TfNSW reference: REN25/00114/001

Your reference: SSD-64834490

SSD-64834490, Brewongle Solar Farm, 315 Tarana Road, Brewongle; Response to Environmental Impact Statement

TfNSW has reviewed the Environmental Impact Statement (EIS) prepared by Environmental Resources Australia Pty Ltd dated 25 March 2025 and Traffic Impact Assessment (TIA) prepared by Amber Organisation dated 29 August 2024, as key documents for preparing this response.

Figure 1: Vehicle chassis outline beyond paved road area / over median (indicated with red ovals) at Great Western Highway & Littlebourne Street roundabout. Source: Brewongle Solar Farm TIA (DWG NO: 781 RA01D)

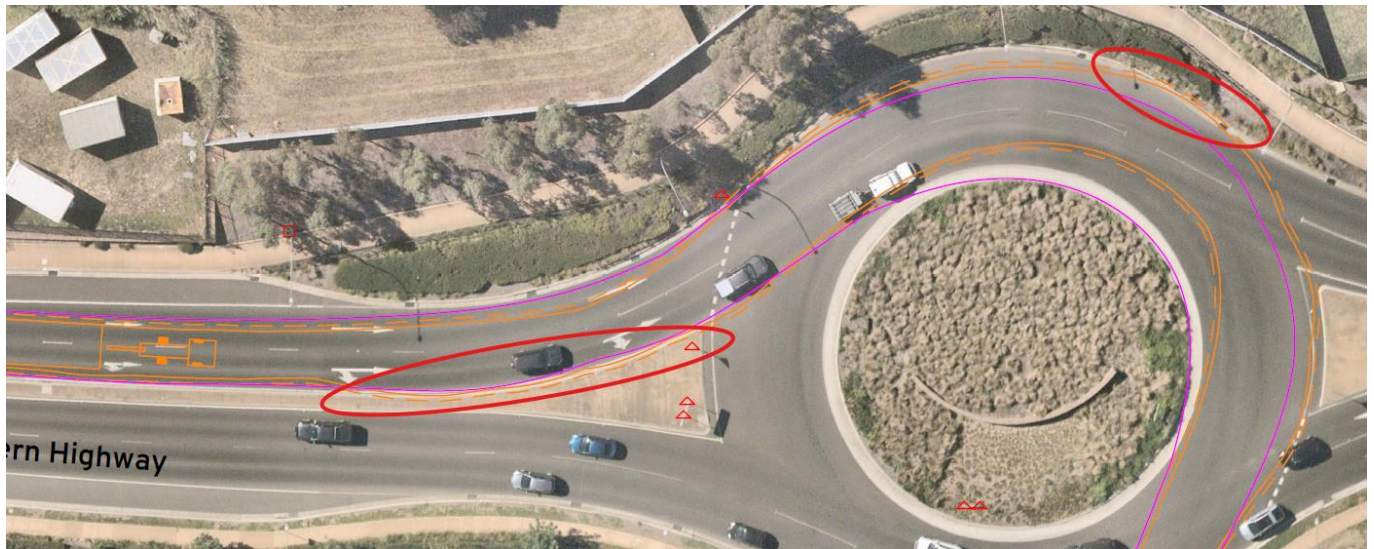
- f. Roundabout at Great Western Highway & Littlebourne Street

- The swept path provided shows the vehicle chassis traversing outside of the paved road area, and over the median island (see figure 1). Strategic concept designs are to be updated and provided with road and/or shoulder widening pavement designs. g. Mid Western Highway, Lyndhurst - Sections of the Mid Western Highway south of Lyndhurst may be narrow. The timing of high-risk OSOM movements may require further consideration and modelling to understand the optimal timing of the high-risk OSOM movements on the state road network and impact of the high-risk OSOM movements through this segment of the corridor as the narrow widths of the travel lanes, minimal shoulders, overtaking opportunities, steel barriers and limited rest area locations will impact on the oncoming and following traffic on this section of the network.
